20118-01-003

**Proposed Community College  
Development at  
Kishogue Cross, Griffeen,  
Lucan , Co. Dublin**

**ROAD SAFETY AUDIT STAGE 1**

May 2021

**Figure 11 Shared entrances for cyclists and pedestrians**

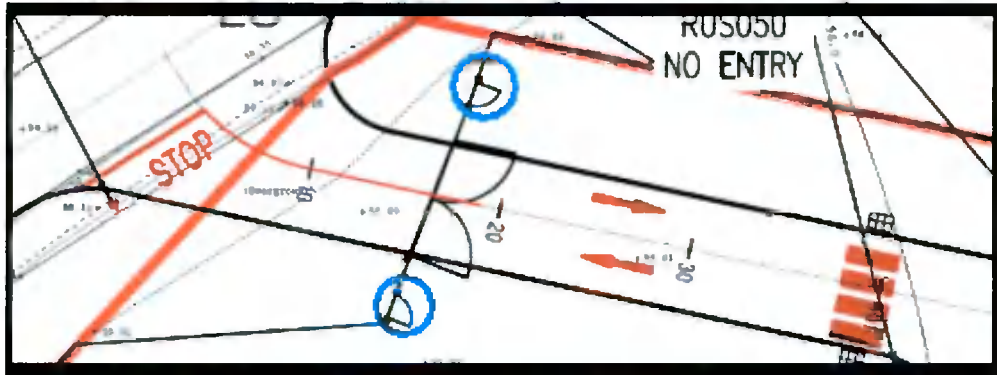
The main entrance to the school off the roundabout on Griffeen Avenue caters for vehicles, with separate shared entrances for cyclists and pedestrians. See Figure 11 and small gateways highlighted in blue

If pedestrians and cyclists enter via the same narrow entrances, this will increase the risk of collisions between cyclists and pedestrians at this location.

Footpaths and Cycleways are not highlighted in any detail on the drawings. However, it does not appear that there is a dedicated cycleway from the entrance to the school to this cycle storage areas shown on the plans.

Without this dedicated cycleway there is a risk of collisions and injuries between cyclists and pedestrians in this part of the school.

Provide for separation of cyclists and pedestrians at the entrance to the school, and wherever possible, continue this separation within the school grounds.

2.4	Yes	Yes	Cyclist will be encouraged to dismount at the site entrance and utilise the footpath to the cycle parking such that there are no cyclist/pedestrian conflicts.	_____

**Figure 15 Overhang on Fire Tender Autotrack**

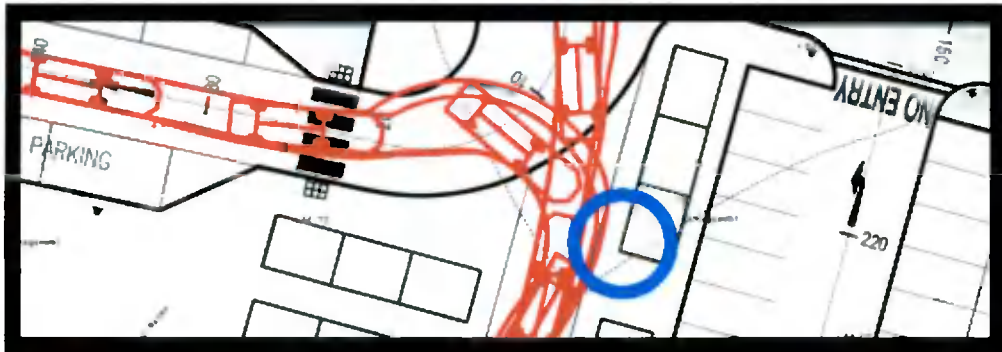
On the autotrack drawing for the Fire Tender, there is a slight overhang onto a footpath adjacent to a pedestrian footpath – see area coloured in blue in Fig 15 below.

This could lead to collisions with pedestrians on the footpath, causing injuries.

Ensure that all vehicles can negotiate the bends on internal roads with ease, can set down without the need to reverse, and would not overhang footpaths when travelling through the school site.

2.6	Yes	Yes	Please refer to Waterman Moylan Drawing No. 19-037-21-P150- Rev A Proposed Swept Path Analysis - Fire Tender which has been updated. The Fire Tender is infrequent and away from high pedestrian areas.	_____

Figure 17 Visibility as Pedestrian Crossing.

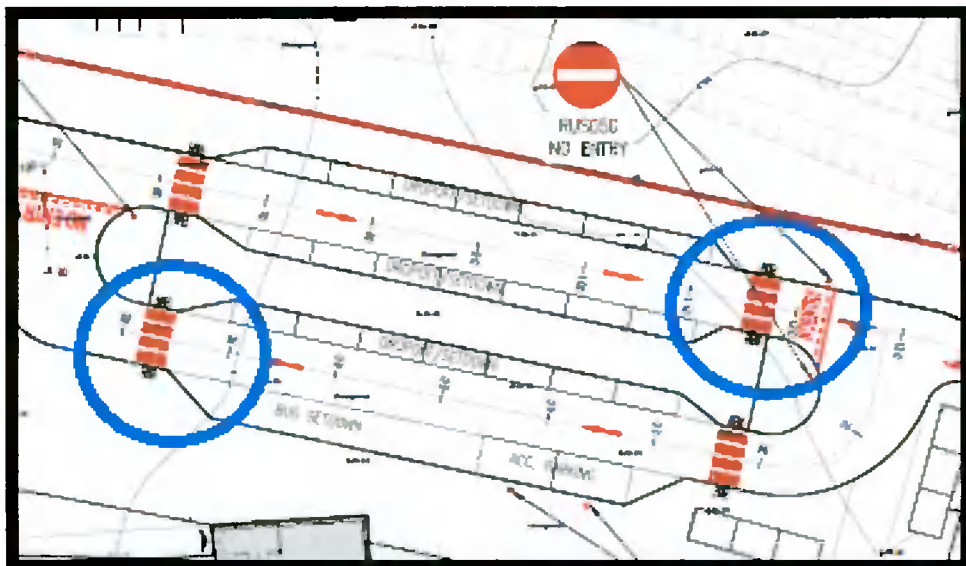
A number of pedestrian crossings are proposed along the school access road. Visibility at some of these proposed pedestrian crossings may be restricted by vehicles stopped in the set-down areas in the vicinity of the proposed crossings.

Ensure adequate visibility splays are provided at all the pedestrians crossing locations.

2.8	Yes	Yes	We can confirm that the visibility splays at pedestrian crossing points located in the subject site is adequate.	_____

TITLE: PROPOSED SIGHTLINES

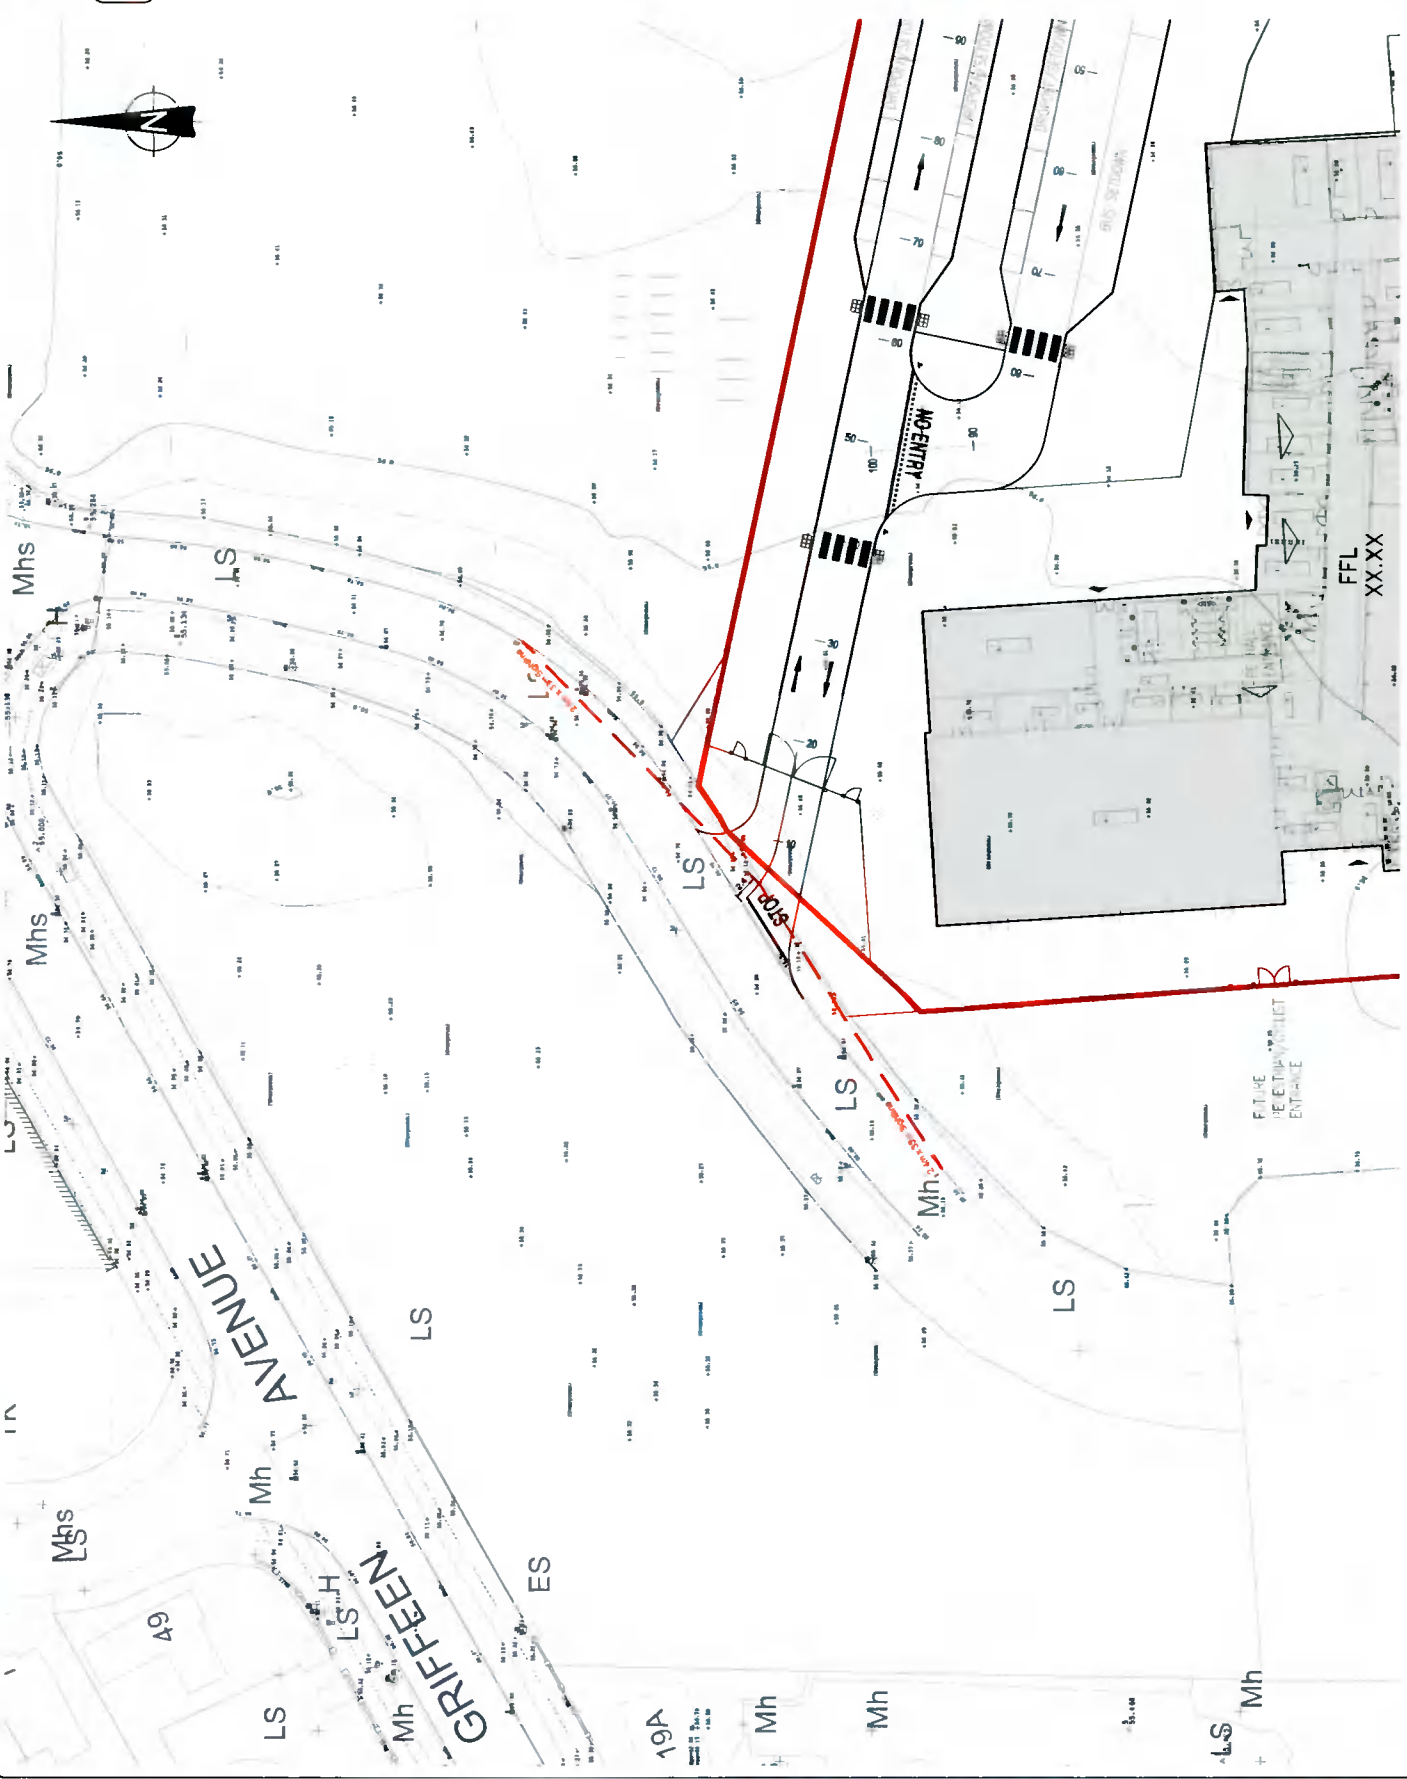
The speed limit on Griffeen Avenue is 50 kilometres per hour. There does not appear to be any signs showing a change in speed limit on the roadway down to the Educate Together School and the proposed new Community School. See Figure 16 below.

This means that in theory motorists can drive at 50 kilometres an hour on the roadway to the school, where there will be a lot of children in the vicinity at peak times.

This could lead to an increased risk of collisions between vehicles and pedestrians or cyclists on this roadway.

Consideration should be given to liaising with the local authority to install periodic speed limits on this roadway, to govern speeds at school opening and closing times.

2.7	Yes	Yes	Please refer to Waterman Moylan Drawing No. 19-037-21-P111- Proposed Sightlines which shows the speed on the existing access road will be set to 30kph as required by SDCC.	_____
